# 1015 LAKE DAVIS REPLAT

## SUMMARY

# BOUNDARY SURVEY

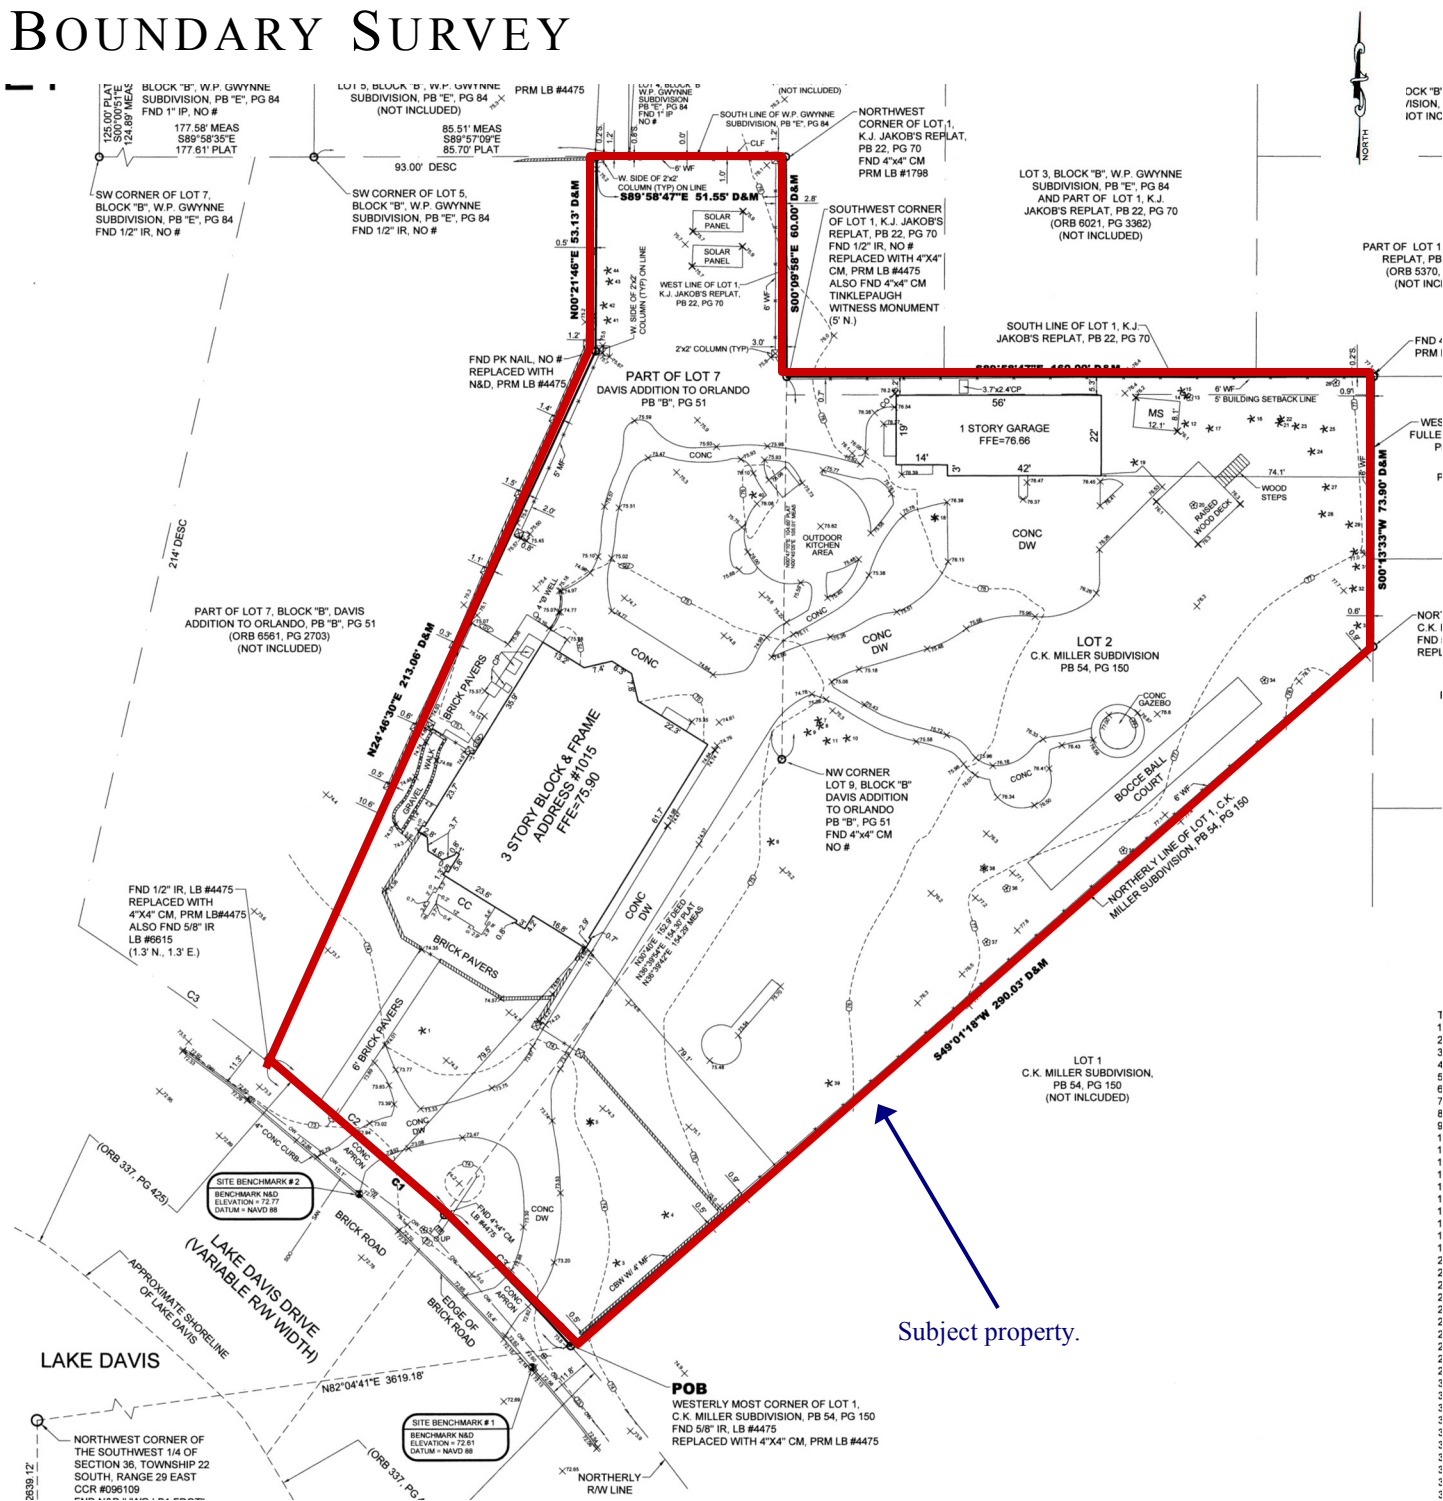
1. Sheet: (Survey) The west C-3 appears to be a typo error.
2. Sheet: (Survey) The concrete driveway appears to encroach onto lot-2 with the replatting.
3. Sheet: (Plat) Please supply the re-establish record information of the CCR 055876.
4. Field Review has passed. FS 177.091(7)
5. Orange County Property Appraiser has not completed their review at this time.
6. Reminder: A copy of the Statement of Lien Settlement must be provided to the Office of Permitting Services when the plat is ready for recording. CO(17)
7. Survey will need the following documents for the next review in addition to copies required by other departments:
  - a. 2 copies of the plat
  - b. 2 copies of survey
  - c. Email, CD, or flash drive containing PDF files of all documents.

## PROPOSED PLAT

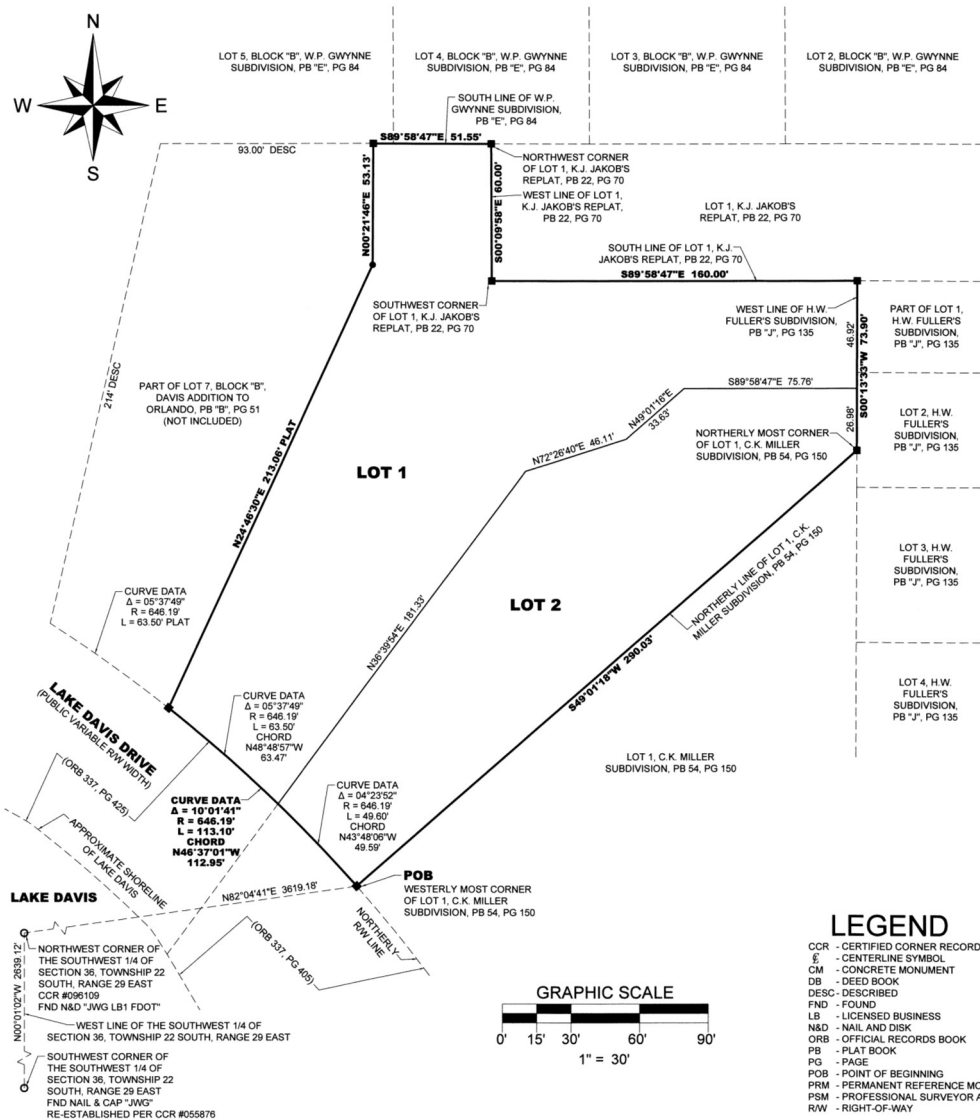
6. Plat– Minor. Plat Face Changes - There are a number of changes required to the face of the plat. In addition to the changes required on the plat, the following is a list of additional requirements. 1) Changes to the face of the plat. (A copy has already been returned to the surveyor). 2) Recording Fees (Checks should be made payable Orange County Comptroller.) 3) The plat must be reviewed by Orange County prior to recording. Begin this process by taking a copy of the executed plat to Room 1700 (Orange County Property Appraiser's Office, Attn. Rocco Campanale), 200 S. Orange Avenue, Sun Trust Bank Center. The original completed Statement of Lien from Orange County is required by this office. The Statement of Lien must be received by this office prior to recording the plat.

7. Easement– Encroachment. The final plat shall contain the following note: There shall be no building encroachment, roof-over-

# SITE PLAN

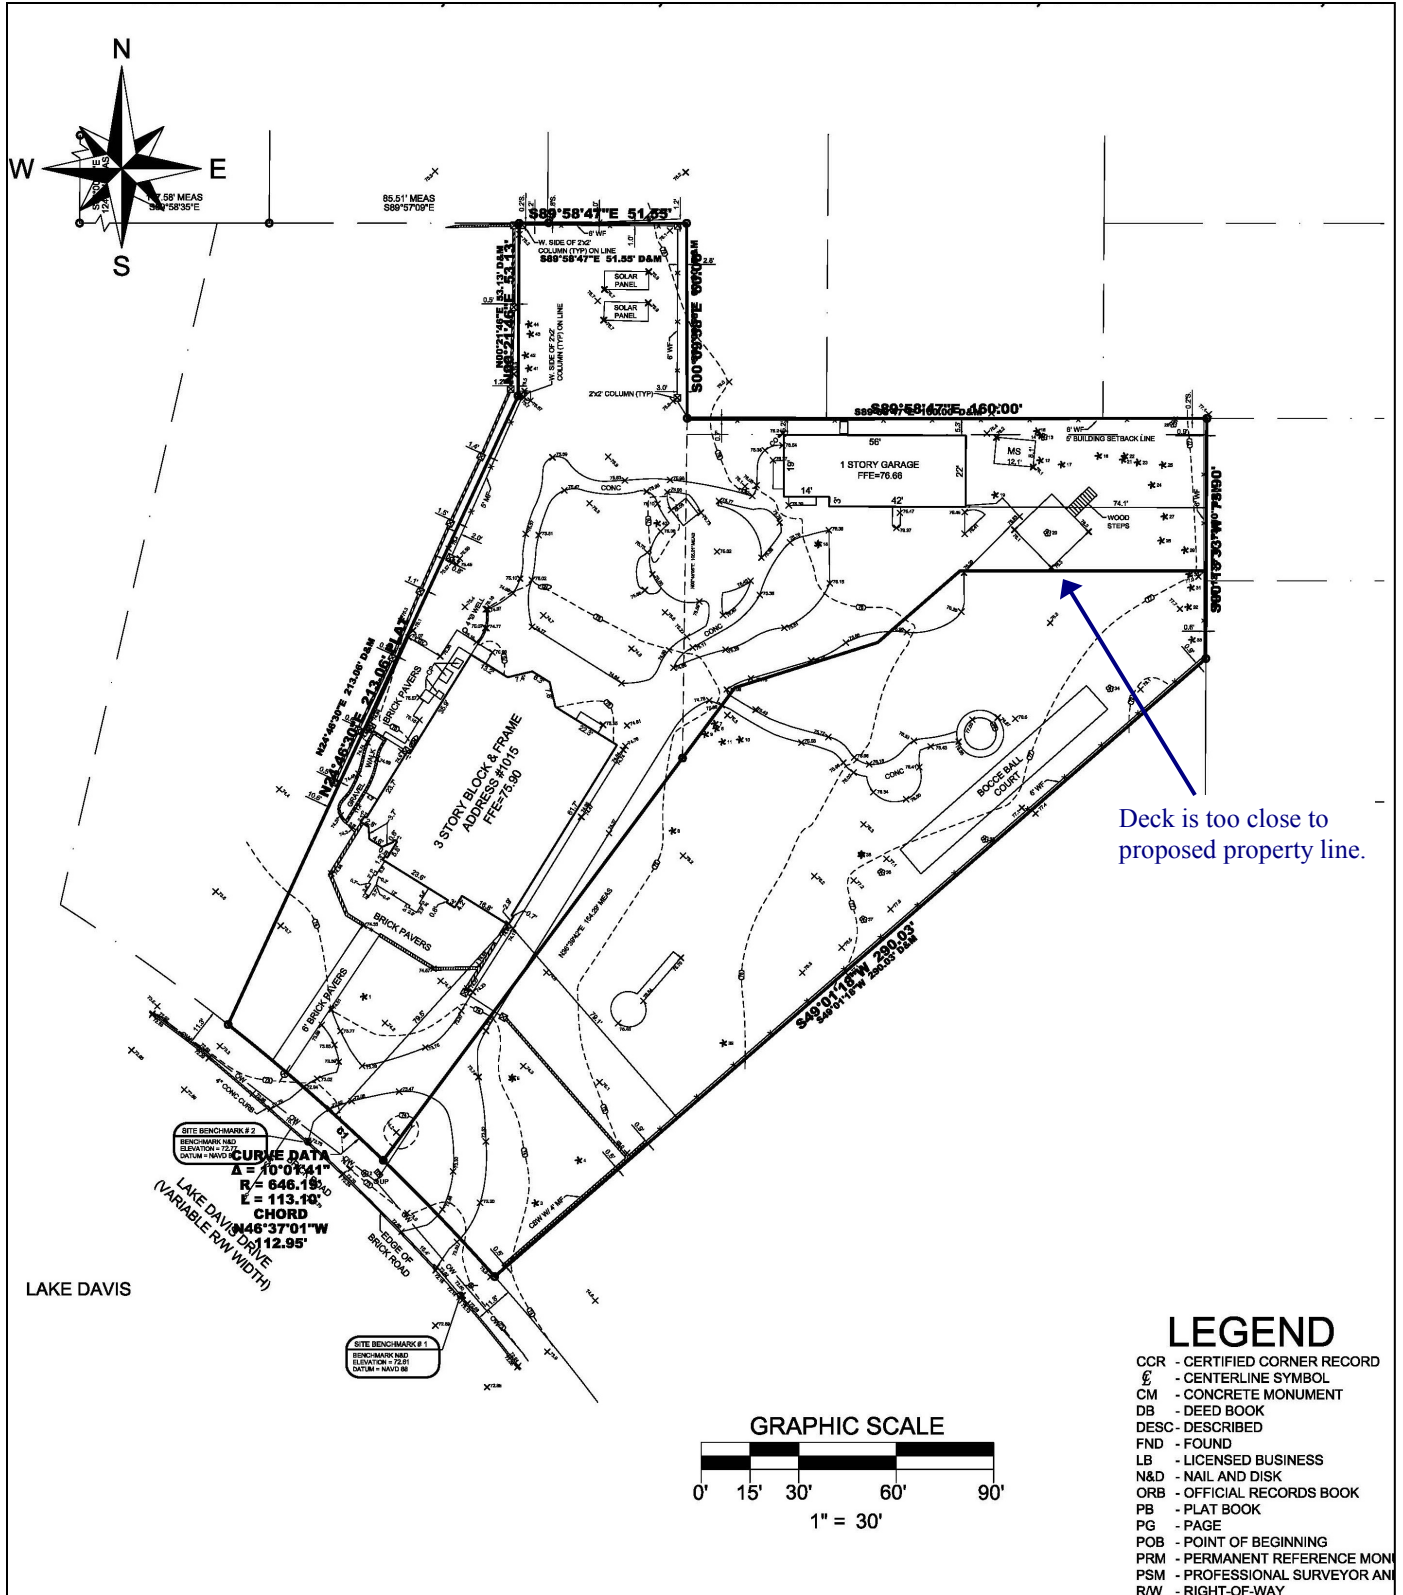
Currently a wooden deck is located along the rear of proposed lot 1. The proposed reconfiguration results in an approx. 1 ft. side setback for this deck where the minimum code requirement is 5 ft. Code compliance shall be required either through adjustment of the lot line, removal of the deck or approval of a variance.

1. General Code Compliance. Development of the proposed project shall be consistent with the conditions in this report and all codes and ordinances of the City of Orlando, the State of Florida and all applicable regulatory agencies.
2. Deck Setback. Code requires a 5 ft. side setback for decks. Code compliance shall be obtained either through adjustment of the lot line, removal of the deck or approval of a variance.
